MEMORANDUM

TO: University Heights, Mayor, Council, and Staff
FROM: Josiah Bilskemper, P.E.
DATE: August 10, 2015
RE: City Engineer's Report

(1) One University Place – Sensitive Areas Development Plan, Site Plan and Grading Plan

BORING LOCATION PLAN

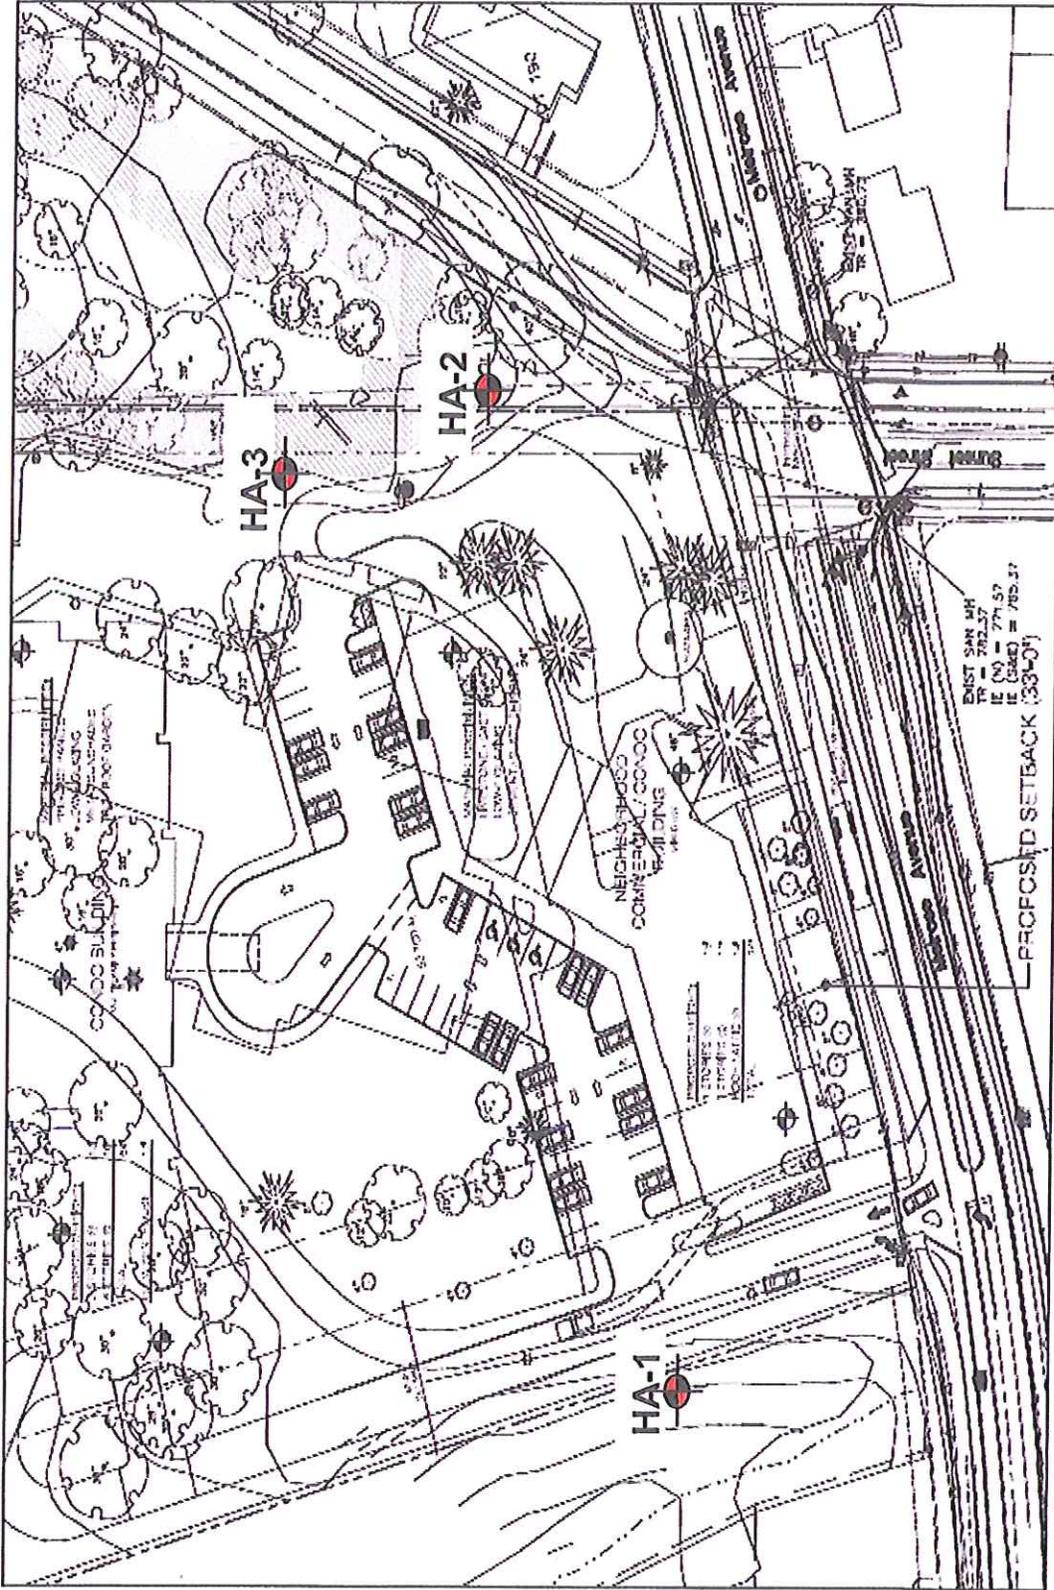
As requested, three hand auger borings were performed at selected locations along sensitive slope areas classified as "Protected Slope" within the proposed project site. Based on visual examination of the soil samples obtained from these hand auger borings (see attachments), the following observations are made:

- Existing variable fill materials were encountered in the hand auger borings. These fill materials are primarily composed of lean clay with varying amounts of sand, crushed stone pieces, asphalt pieces, cinders, and rubble.
- Hand auger refusal was encountered at depths of about 3 to almost 5 feet below the existing grade where apparent rubble was encountered.

In summary, the areas of the hand auger borings contained random fill materials and these materials are considered to be areas which have been altered by human activity. In addition, it is our opinion that the existing slopes have a relatively low factor of safety against a deep-seated slope failure. Thus, it is our opinion that the proposed development should be designed such that the stability of the slopes are improved.
